# KwikStik-K40

## Hardware Errata

Rev. 5

This report describes hardware errata of the Kinetis KwikStik (KWIKSTIK-K40) development tool hardware.

## KWIKSTIK\_01: K40X256 MCU cannot be turned OFF using the ON/OFF switch

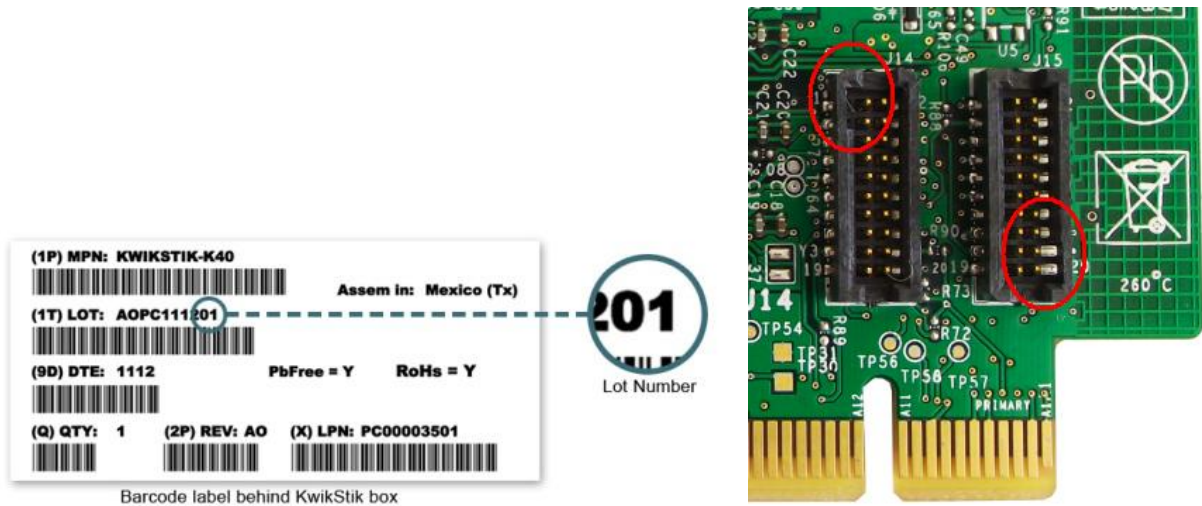
When the ON/OFF switch SW1 is in the OFF position, the K40 MCU is not turned off. This can cause unexpected behavior when trying to use the JTAG connector for external device programming and debugging.

Removing power supply to VREFH will allow the K40 to be switched off. To do so, remove ferrite F5.

# KWIKSTIK\_02: TWRPI connectors populated in a wrong orientation

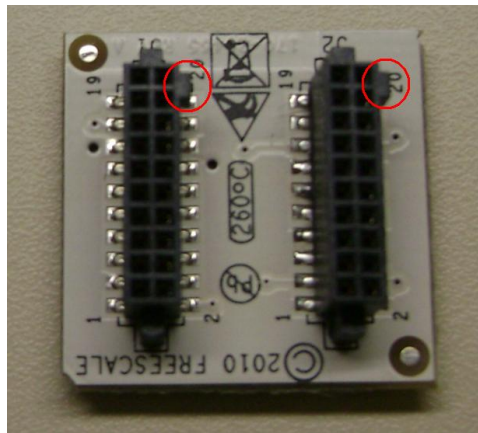
KWIKSTIK-K40 PWA Rev A/3.0 Boards of shipment lots 01-04 may have the TWRPI connectors (J14, J15) populated in a wrong orientation.

To use the TWRPI interface you will need to remove the key/notch from the female connectors of the TWRPI boards.

## KWIKSTIK\_06: Undersized VOUT33 Capacitor

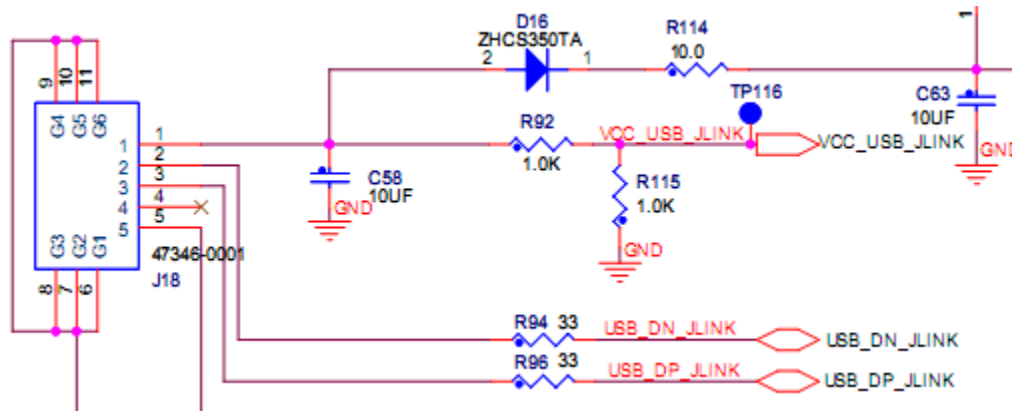
The recommended value for the capacitor from VOUT33 to GND is from 1.76 $\mu$ F to 8.16 $\mu$ F with 2.2 $\mu$ F being the typical value. The capacitor (C34) connected to VOUT33 on the KwikStik is only 0.1 $\mu$ F. This can result in unstable or non-functioning USB operation.

Replace C34 with a capacitor of value 1.76 $\mu$ F to 8.16 $\mu$ F.

## KWIKSTIK\_07: Failure to Power from J-Link USB

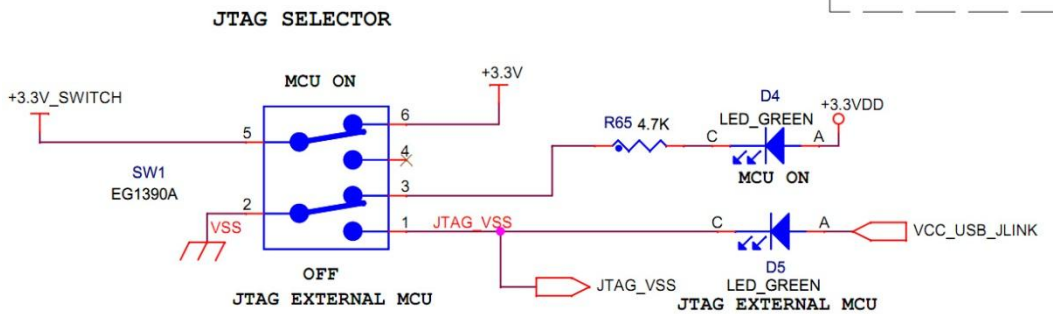
R114 is identified as a 10.0Ω resistor on the schematics but may be populated with a 0Ω resistor. When power is applied to the J-Link USB connector, J18, current will flow through D16 and R114 to charge C63 and provide power to the +5V\_USB supply. D16 is rated for 500mA. Without a resistance on R114 D16 may exceed its rating and it may fail to operate correct resulting in the inability to power the KwikStik from the J-Link USB connector.

Replace R114 with a 10Ω resistor. Power may still be applied to the other USB connector, J17 to source power to the entire Kwikstik, including the J-Link circuit. If powered from J17, the J-Link interface will continue to operate properly as a debug interface.

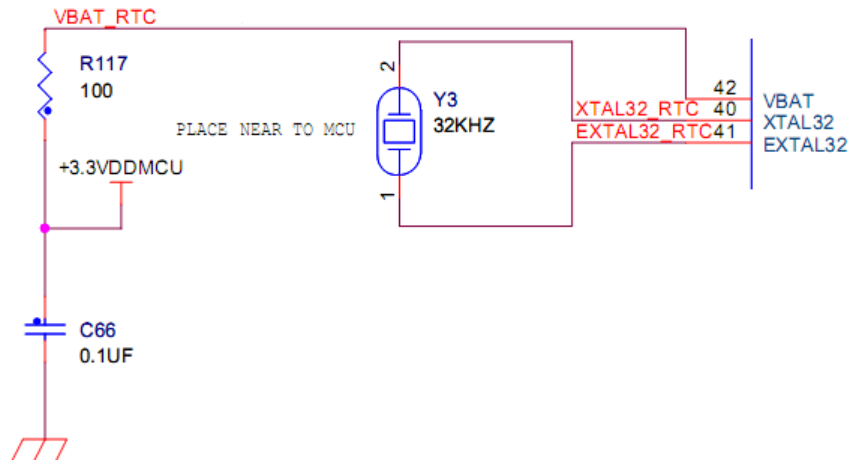
- 1) KWIKSTIK\_01 Errata was corrected. SW1 switch effectively powers down the K40 MCU

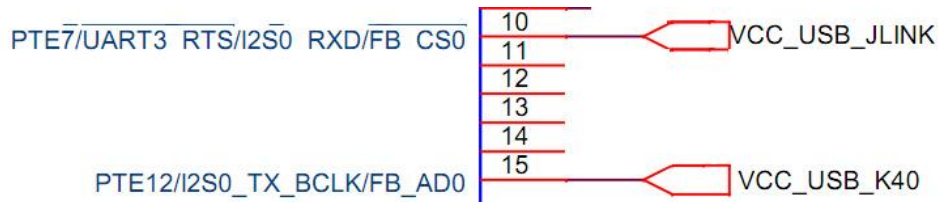
- 2) Added R117 and C66 connecting the RTC VBAT (K40X256 pin 42) to the 3.3V MCU supply.
